Product Change Notification Number: PCN262401	Date: 12.06.2026
--	-------------------------

Title: SHT85 - FilterMembraneChange

Product Identification: SHT85 (3.000.074)

Current solution:

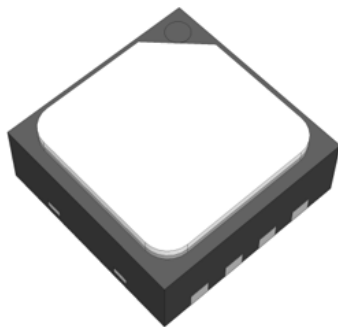
Change Description:
 Transition of the sensor filter membrane material from PTFE (Polytetrafluoroethylene) to PI (Polyimide).
 This change allows the implementation of highly scalable manufacturing processes and ensures our capacity to meet growing market demand and enhances the resilience of our supply chain.

The sensing element of SHT85 will change the appearance.

New solution:

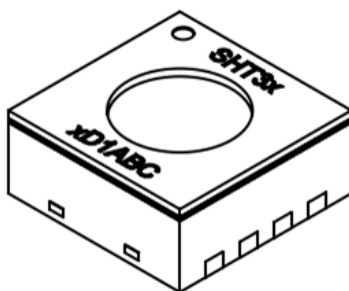
- Function and performance: **Unchanged**. The sensor specification, accuracy and response time remain identical. The PI membrane is IP68 certified and provides equivalent protection against dust and particles.
- Fit: Full backward compatibility with existing PCB layouts.
- Appearance: The sensor will have distinct visual appearance due to the new membrane material (see image comparison below).
